**194 – 214 OXFORD STREET AND 2 NELSON STREET,  
BONDI JUNCTION NSW**  
OXFORD AND NELSON (THE CENTENNIAL COLLECTION)

**BCA 2022  
COMPLIANCE REPORT FOR  
CONSENT AUTHORITY SUBMISSION**

DATE: **3 MARCH 2025**  
REPORT NO: **3011\_SSDA – REV A FINAL**  
PREPARED FOR: **STARGATE PROPERTY C/- VERNON HOUSTON**  
PREPARED BY: AM | **J<sup>2</sup> BCA CONSULTING**

**Figure D - Openings located within 3m of the allotment boundary caused by the allotment boundaries (typical basement levels)**

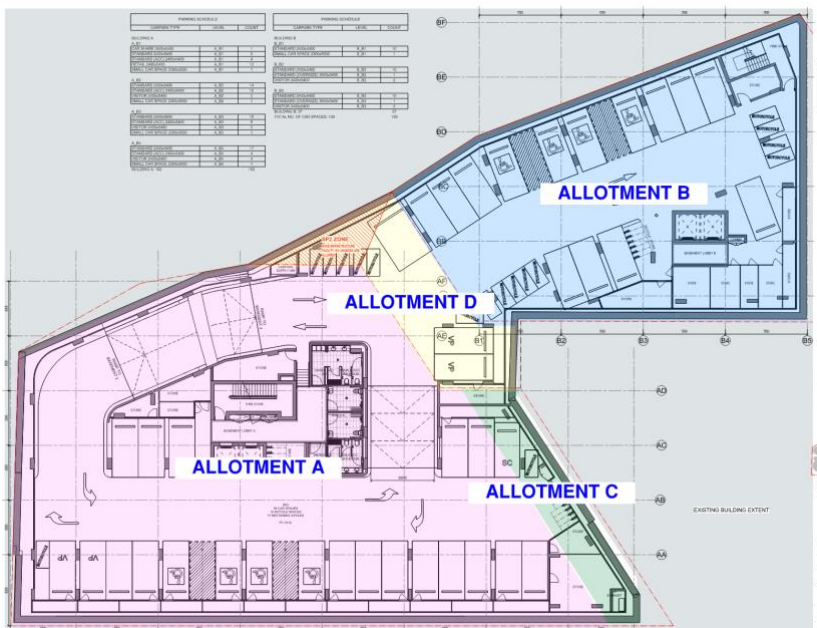
NO.	DTS CLAUSE	DESCRIPTION OF NON-COMPLIANCE	RECOMMENDATION
5.	C4D3 C3.2	<p>Protection of openings in external walls</p> <p>If the distance between an opening and the fire-source feature to which it is exposed to is less than: 3m from a side or rear boundary of the allotment, 6m from the far boundary of a road, river, lake or the like adjoining the allotment, if not located in a storey at or near ground level or 6m from another building on the allotment that is not a Class 10.</p> <p>Additionally, in conjunction with the requirements of BCA Clause C2D2 and Specification 5, the building contains various allotment boundaries which are located through the basement levels.</p>	<p>It is proposed to amalgamate the allotment titles/boundaries to resolve this item to achieve compliance with the prescriptive requirements.</p>

Figure H – Separation of exits (residential) scissor stair configuration (Tower A)

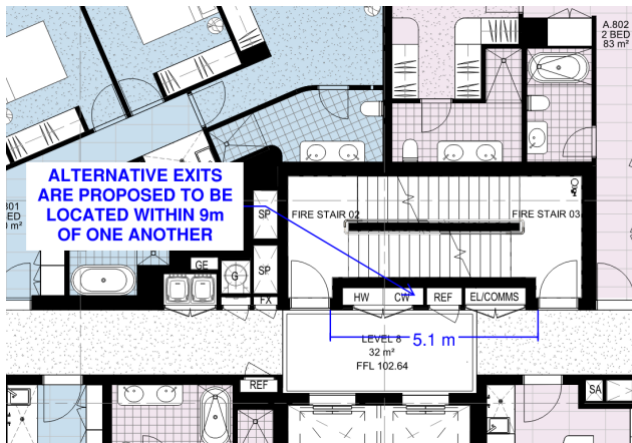
Upper Residential Levels: The upper residential levels are within 9m of one another.

**Figure J – Fire isolated stair opens directly into SOU**

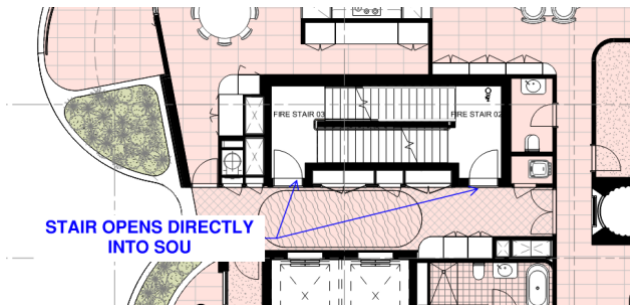
there is additional units within Building B. Therefore, this is a technical non-compliance, as shown below:

**Figure K – Tower A discharge of fire isolated stairs (Oxford Street Tower)**

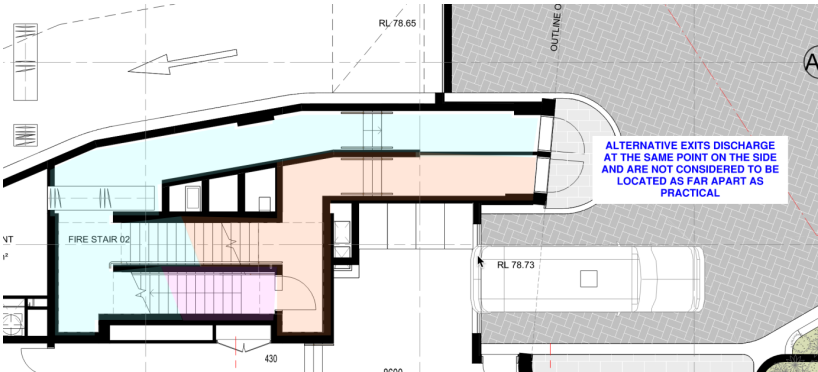
**Tower A Stair Discharge:** The fire isolated stairs within the Oxford Street tower exits converge within the same fire isolated passageway at the ground floor. This appears to discharge to open space/open sky and is connected to the road. This arrangement is shown below:

As occupants discharging from FS.03 does not necessitate passing by the shopfront (glazing) this is not considered a technical non-compliance as occupant have a point of choice from this stair.

**Figure L – Discharge of FS.01 from Tower B requires occupants to pass by unprotected openings within 6m of the path of travel**

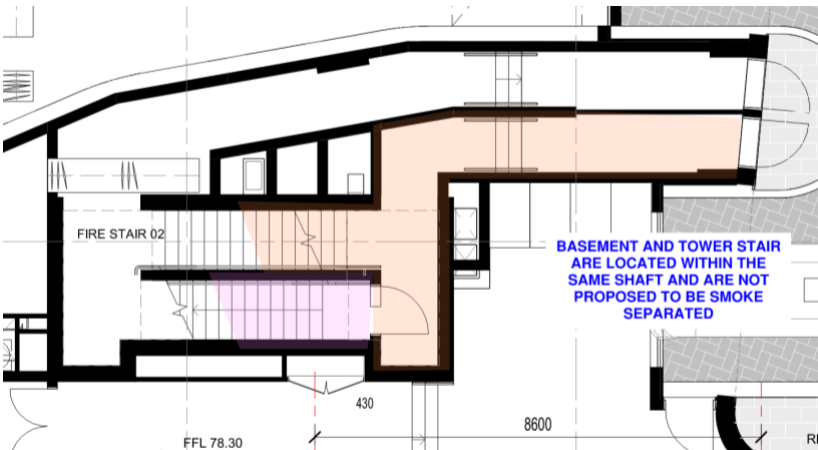
**Tower B (FS.01) discharge:** The fire isolated stair discharges adjacent to the retail tenancy which requires occupants to discharge within 6m of unprotected openings (glazing of the shopfront).

NO.	DTS CLAUSE	DESCRIPTION OF NON-COMPLIANCE	RECOMMENDATION
12.	D2D15 <i>D1.10</i>	<p>Discharge of exits</p> <p>The discharge point of alternative exits must be located as far apart as practical. Due to the scissor stair configuration of the residential portions of the building the discharge point is located on the same point on the site. This specifically relates to the alternative exits within the Tower located on the Oxford Street property (residential portions). This is shown below for reference.</p>  <p><b>Figure M - Discharge of alternative exits (Tower A)</b></p>	A Fire Engineered Performance Solution may be sought to address this item.

Figure O - Vehicle ramp within Basement 01

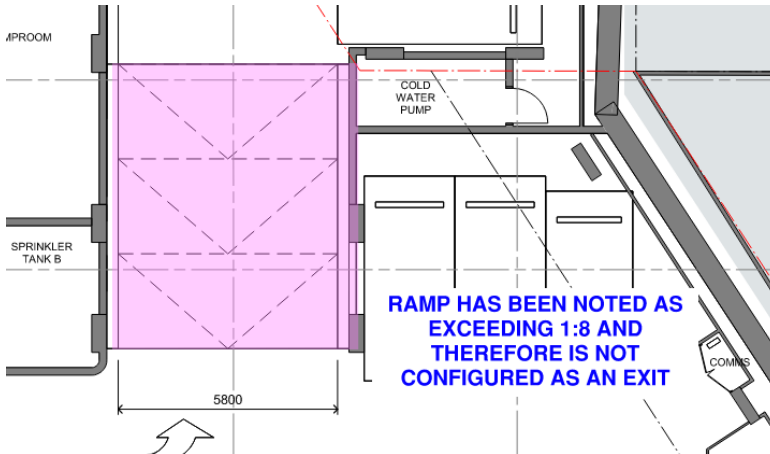
Where the vehicle ramp located within Basement 01 and 02 is configured as a 1:8 ramp, this may be considered a pedestrian ramp to provide access to a secondary exit, required by BCA Clause D2D3, this ramp is shown below:

**Figure Q – Change in level between indoor and outdoor levels**

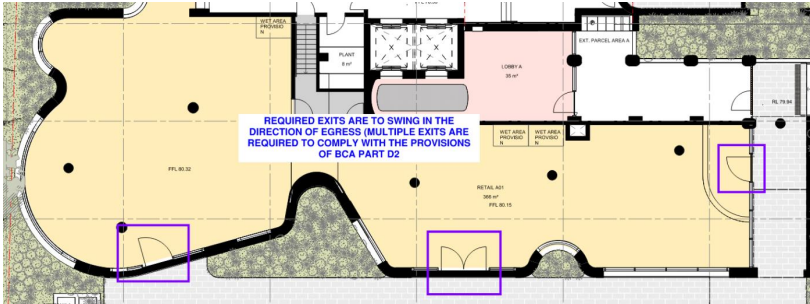
NO.	DTS CLAUSE	DESCRIPTION OF NON-COMPLIANCE	RECOMMENDATION
15.	D3D16 <i>D2.15</i>	<p><b>Thresholds</b></p> <p>The threshold of a doorway must not incorporate a step or ramp at any point closer to the doorway than the width of the door unless:</p> <p>In a building required to be accessible by BCA Part D4, the doorway opens to a road or open space and is provided with a threshold ramp or step ramp in accordance with AS1428.1-2009. Where this occurs, as the doorways do not discharge to a road or open space this is considered a technical non-compliance.</p> <p>The doorways accessing the roof top terraces are likely to contain a set down (either a step or threshold ramp) to achieve compliance with the weatherproofing requirements of the BCA. This is typically located in the following highlighted area:</p>	<p>Where this occurs, as the doorways do not discharge to a road or open space this is considered a technical non-compliance.</p> <p>To be designed to comply. Where this occurs, a BCA Performance Solution may be sought to address this item.</p>

Figure T – Window located within shower alcove

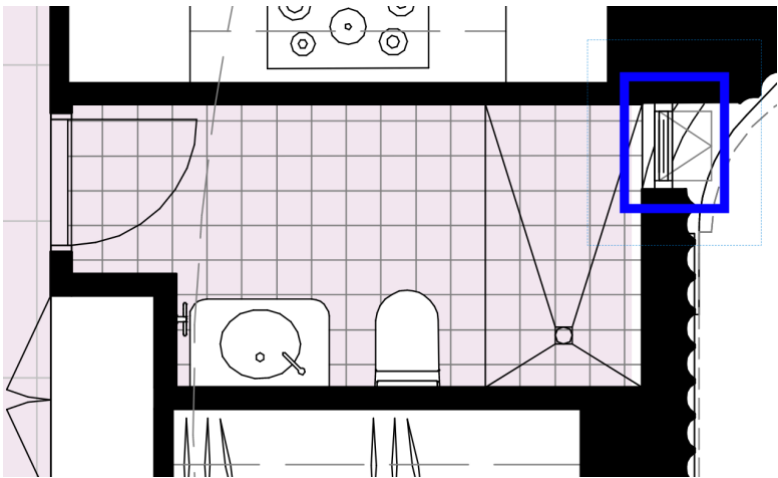
24.	F2D2 <i>F1.7</i>	<p>Wet area construction</p> <p>In a Class 2 building, building elements must be water resistant or waterproof in accordance with Specification 26. Alternatively, compliance with AS3740 is required.</p> <p>The requirements of AS3740 does not recognise that a window is a water-resistant substrate and therefore a Performance Solution is required to detail the waterproofing junction requirements for any windows within a shower. This occurs within various areas of the building, as shown below:</p>	<p>A BCA Performance Solution may be sought from a waterproofing specialist.</p> <p>Alternatively, where the windows are confirmed as achieving an FFL of greater than 1800mm compliance will be achieved.</p>

**Figure 9 – Exit from BOH requires occupants to pass through the retail SOU**

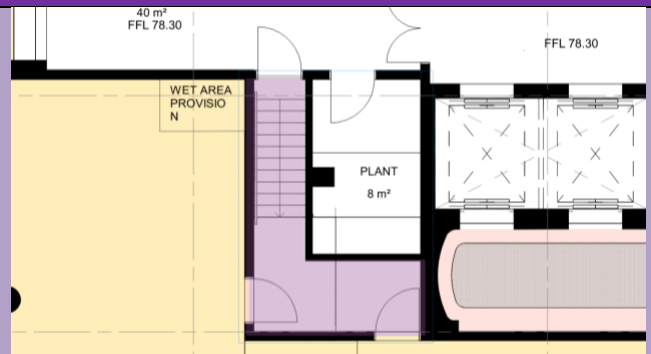
A Fire Engineered Performance Solution is required to be sought to address this item.

Figure 16 - Basement 04, distance of travel to a single exit is in the order of 35.5m

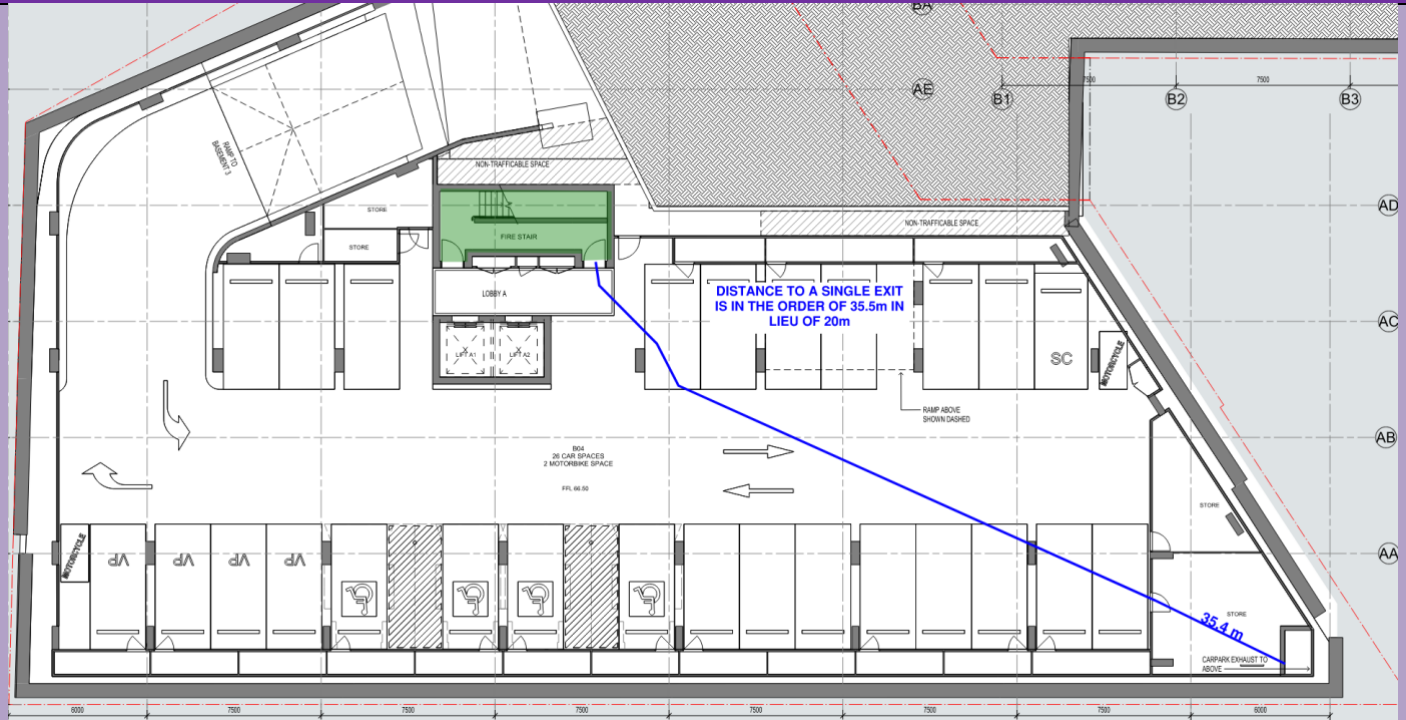
CLAUSE	REFERENCE	APPLICABLE	COMPLIES	COMMENT
				<p><u>Basement 04:</u> Distance to a single exit is in the order of 35.5m. This measurement is shown below.</p> <p><u>Basement 03:</u> Distance to a point of choice is approximately 35.5m in lieu of 20m. An exit is provided within 40m.</p> <p><u>Basement 02:</u> Distance of travel to a single exit is approximately 41m in lieu of 20m. Where the vehicle ramp is configured as a 1:14 gradient, a point of choice may be provided. Note. this is a new non-compliance due to the change in configuration on this level.</p> <p><u>Basement 01:</u> Distance of travel to a single exit is approximately 41m in lieu of 20m. Where the vehicle ramp is configured as a 1:14 gradient, a point of choice may be provided. Note. that this has increased due to the change in door location.</p> <p>A Fire Engineered Performance Solution is required to be sought to address this item.</p> <p><u>Ground Level:</u></p> <p><u>Ground Level:</u> As per the discussion above relating to the number of exits. The following travel distances are noted:</p> <p>Condenser room: Distance of travel to a single exit is in the order of 25.5m in lieu of 20m.</p> <p>The residential lobbies, substation, retail tenancies/BOHs/larger retail is located within 20m of a single exit or 20m to a point of choice with an overall exit located within 40m.</p> <p>Refer to the Figures with BCA Clause D2D3.</p> <p><u>Residential Levels/sole occupancy units (Tower A):</u> Distance to a point of choice is located approximately 7.5m in lieu of 6m throughout all levels.</p> <p>Compliance may be achieved by relocating the entrance doorway. Alternatively, a Fire Engineered Performance Solution is required to be sought to address this item.</p> <p>Level 11 communal area: Travel distance is in the order of 31m to a point of choice in lieu of 20m.</p> <p><u>Residential Levels/sole occupancy units (Tower B):</u> Distance to a point of choice (or exit, where a single exit is proposed) appears to be located within 6m.</p> <p><u>Level 1 (Tower B):</u> Distance to a point of choice within the common outdoor area is in the order of 27m in lieu of 20m. This is shown below.</p> <p><u>Roof Level (Common areas/Tower B):</u> Distance to a single exit is in the order of 21m in lieu of 20m to a single exit. This arrangement is shown below.</p> <p>The plant room located within Tower B appears to be within 20m of an exit. This is dependent on the location of the plant/equipment. Compliance with this clause is capable of being achieved in this area.</p> <p>To be redesigned to comply or a Fire Engineered Performance Solution is required to be sought to address this item.</p>

Figure 28 – Tower A discharge of fire isolated stairs (Oxford Street Tower)

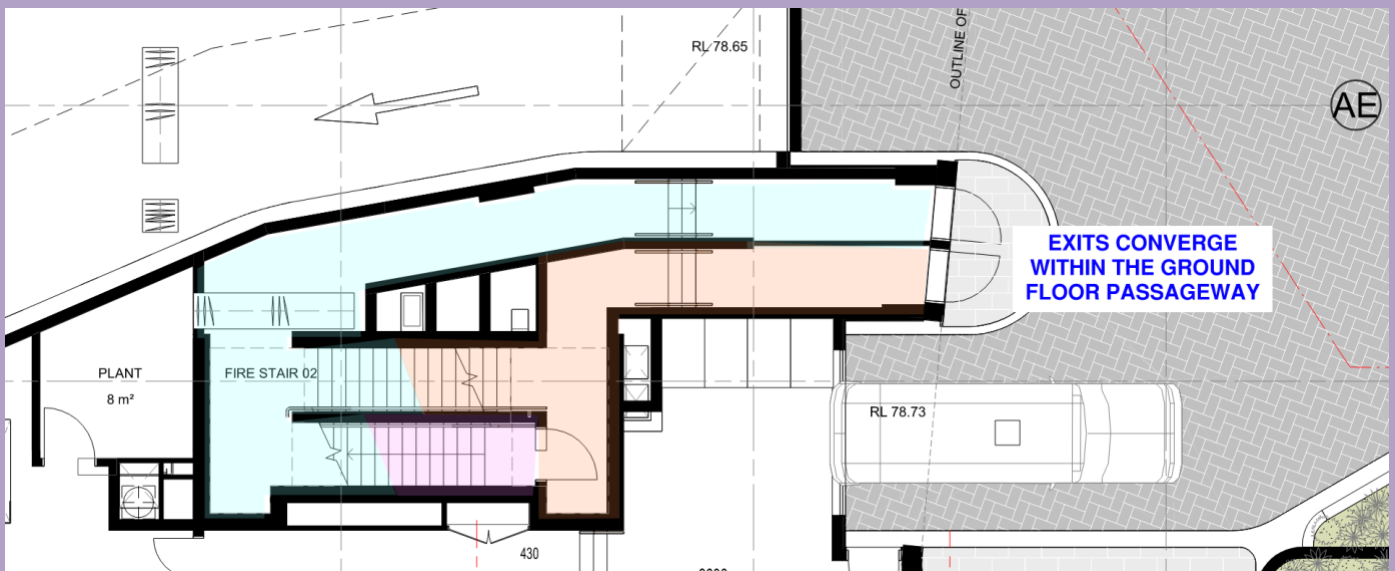
As occupants discharging from FS.03 does not necessitate passing by the shopfront (glazing) this is not considered a technical non-compliance as occupant have a point of choice from this stair.

Figure 30 – Discharge of alternative exits (Tower A)

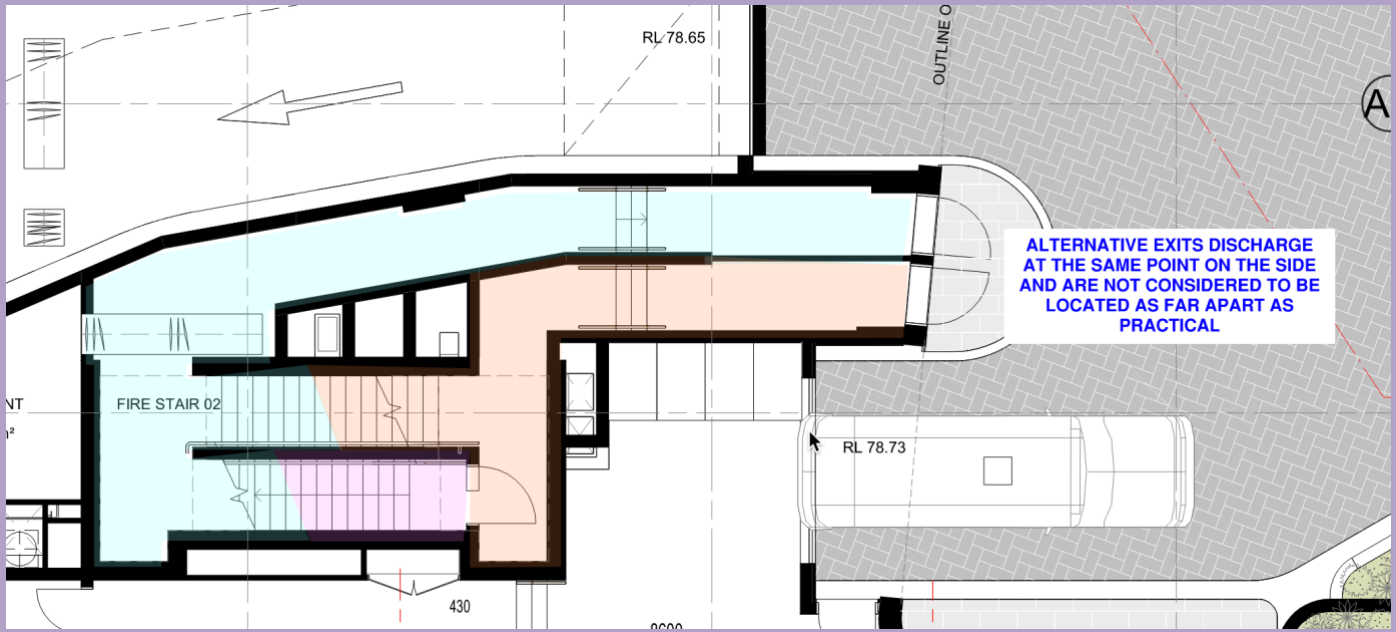
It is proposed to address this item by way of a Fire Engineered Performance Solution.

**Figure 36 – Required exit from the condenser room is required to swing into the stair**

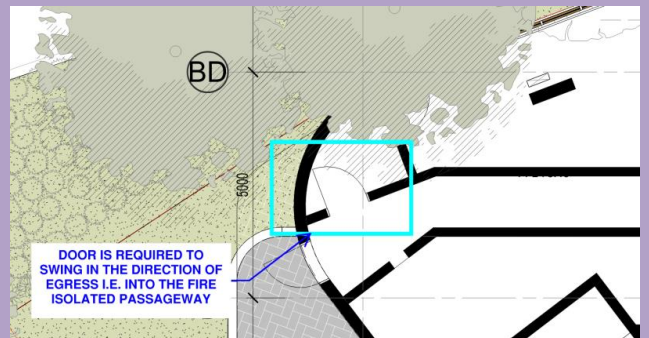
The door from the back of house area located on the Ground Level are required to swing into the fire isolated stair/passageway. This is not currently achieved:

**Figure 43 – Basement 02, sanitary compartment configuration**

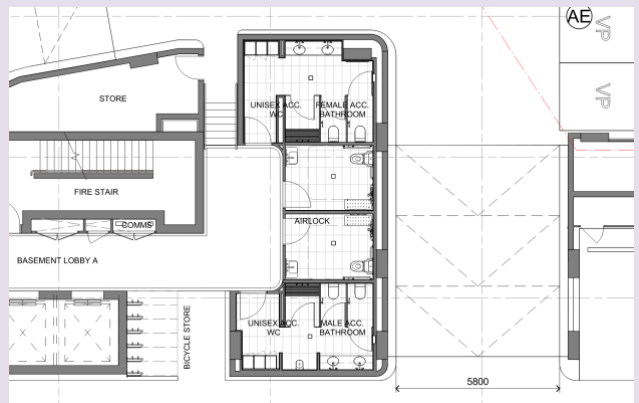
The sanitary compartments within the Basement Level 03 contain two unisex accessible sanitary compartments and a female and male accessible compartment accessed via a common airlock. It is proposed to provide ambulant and accessible sanitary compartment within the male and female sanitary compartments. This is shown below:
